**Request for Additional Information No. 20, Revision 0**

**7/28/2008**

**U.S. EPR Standard Design Certification**

**SRP Section: 09.05.01 - Fire Protection Program**

Figure 9.5.1-1—Fire Water Distribution System  
Sheet 7 of 13

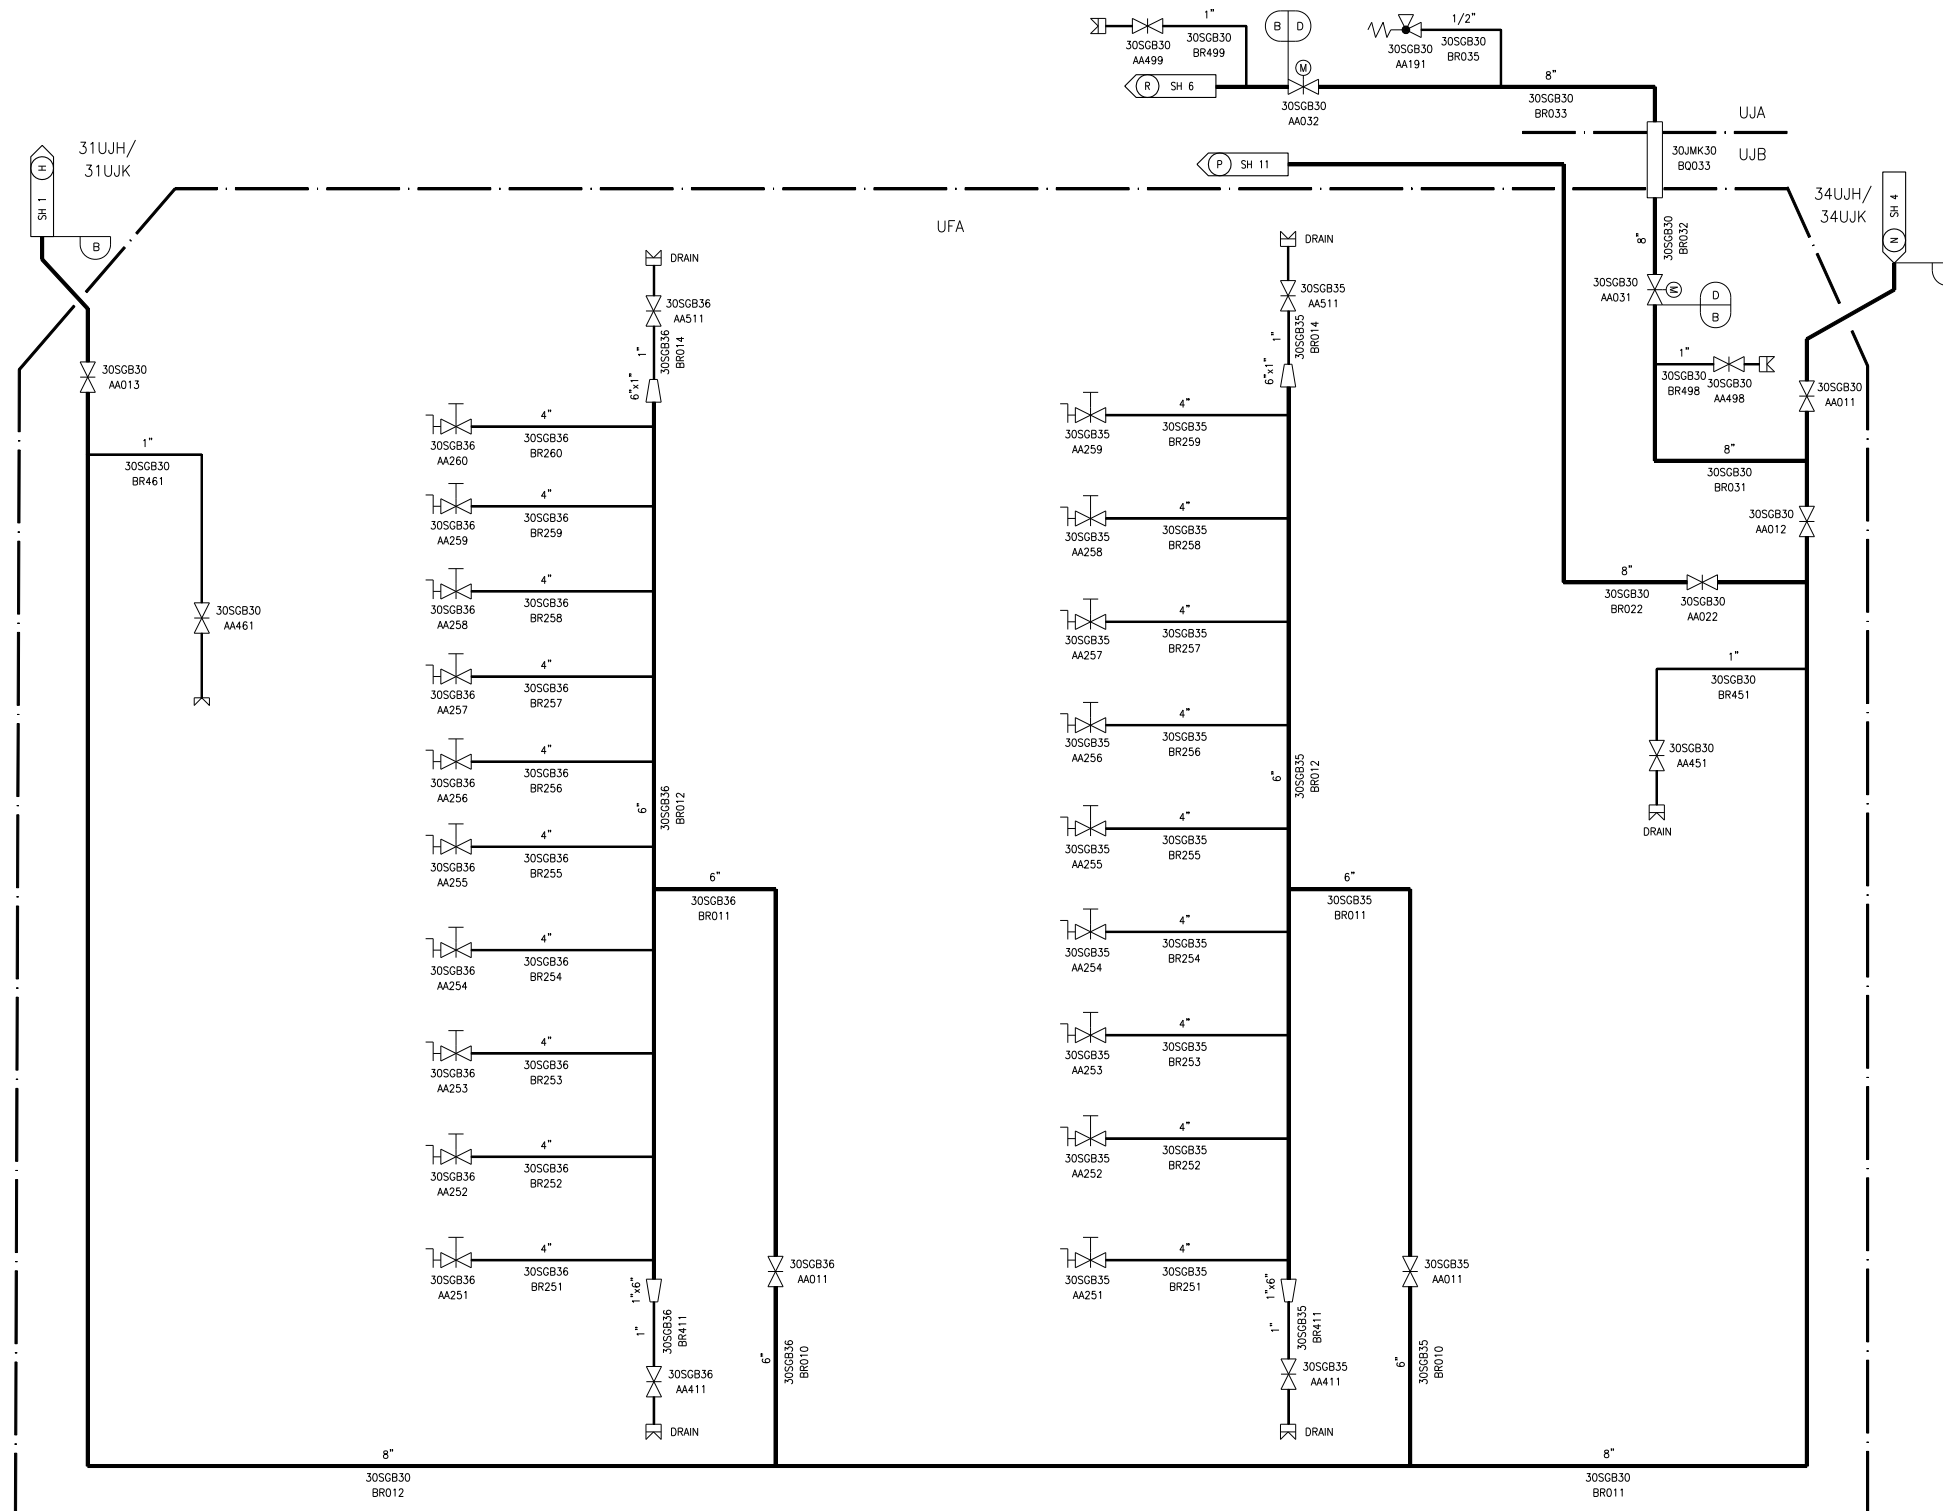
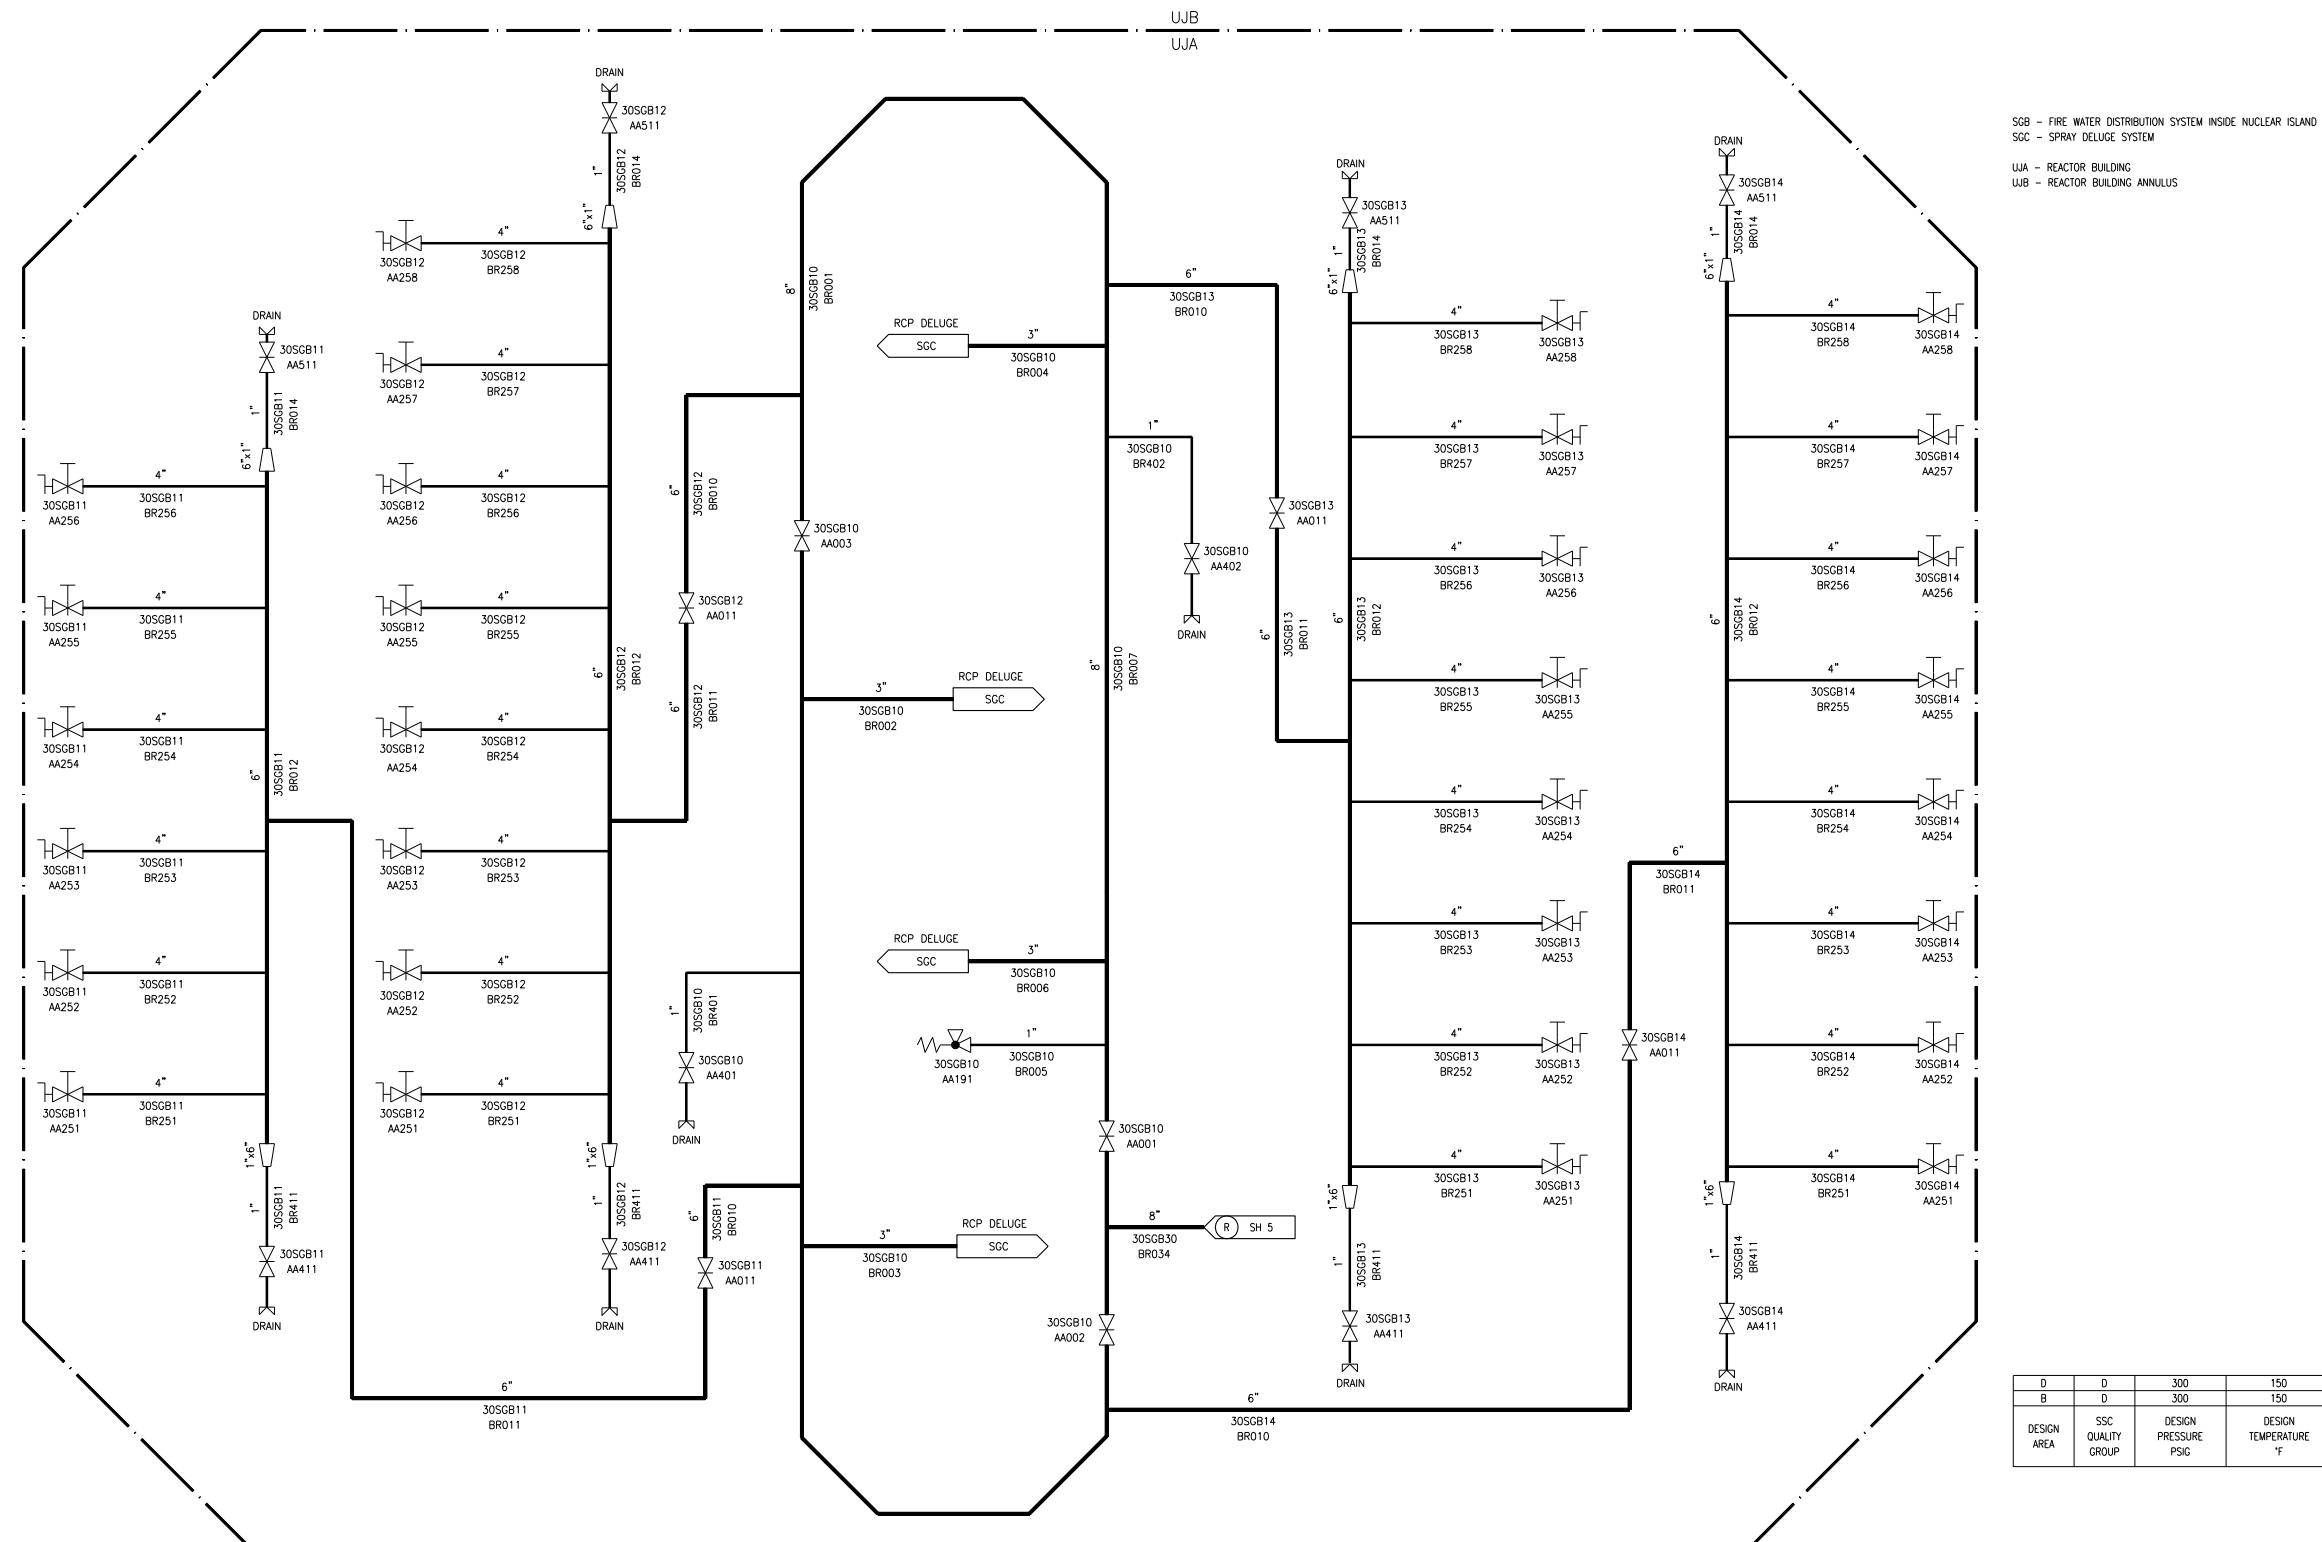
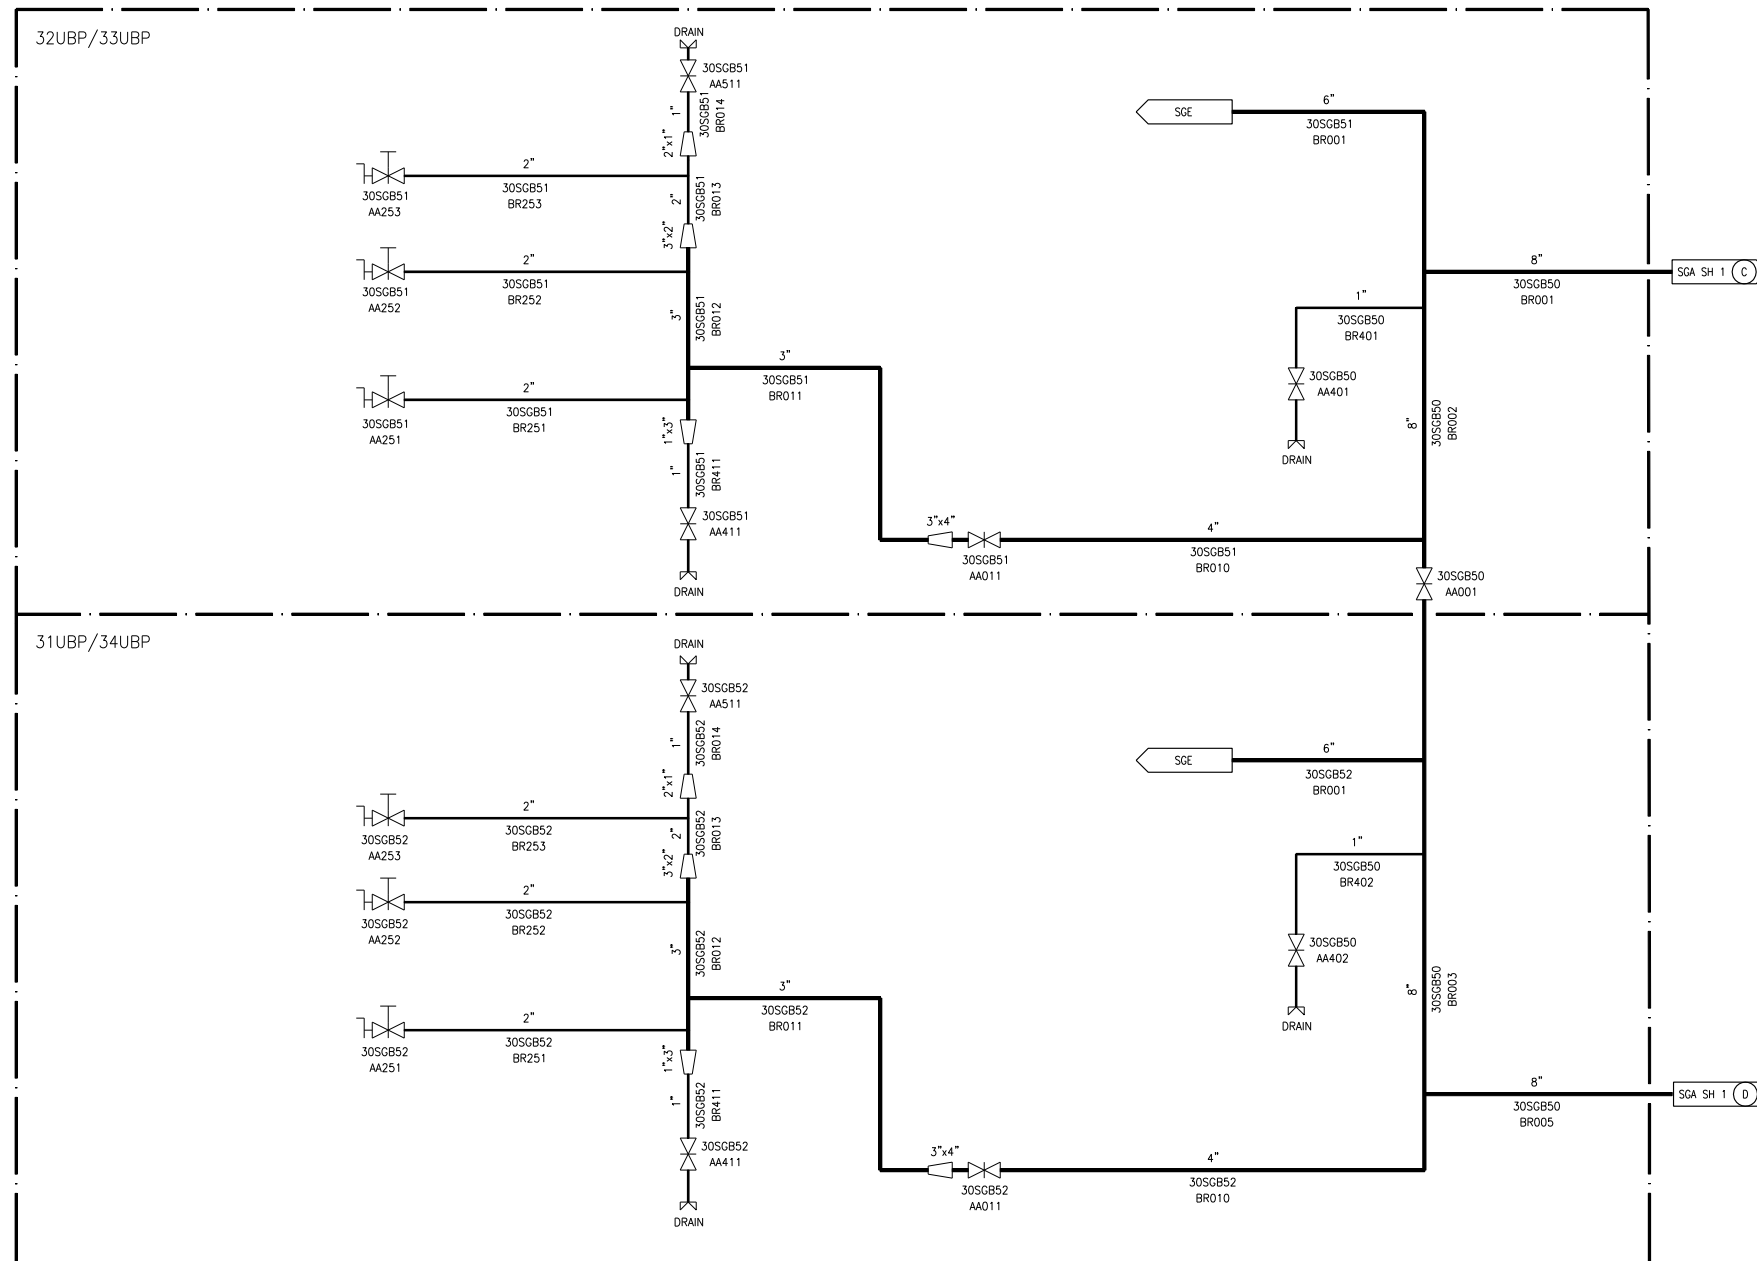
The EPR FSAR should add a COL information item to provide simplified FPS piping and instrumentation diagrams showing complete site-specific systems. Nuclear Island definition is different in Figure 9.5.1-1 then in Tier 1 Section 2.1.1. Modify FSAR accordingly. Basis: Completeness of application.

U.S. EPR FSAR Tier 2, Figure 9.5.1-1 depicts the fire water distribution system for the Nuclear Island (NI) and plant areas not considered part of the NI. However, the current title for this figure is "Fire Water Distribution System Inside Nuclear Island."

The title for U.S. EPR FSAR Tier 2, Figure 9.5.1-1 will be changed to "Fire Water Distribution System." The reference to this figure in U.S. EPR FSAR Tier 2, Section 9.5.1.2.1, under "Fire Water Supply System," will be revised to reflect the new title identified above.

U.S. EPR FSAR Tier 2, Section 9.5.1.2.1 will be revised as described in the response and indicated on the enclosed markup. U.S. EPR FSAR Tier 2, Figure 9.5.1-1 will be revised as described in the response and indicated on the enclosed markup. U.S. EPR FSAR Tier 2, Table 1.8-2 will be revised as described in the response and indicated on the enclosed markup.
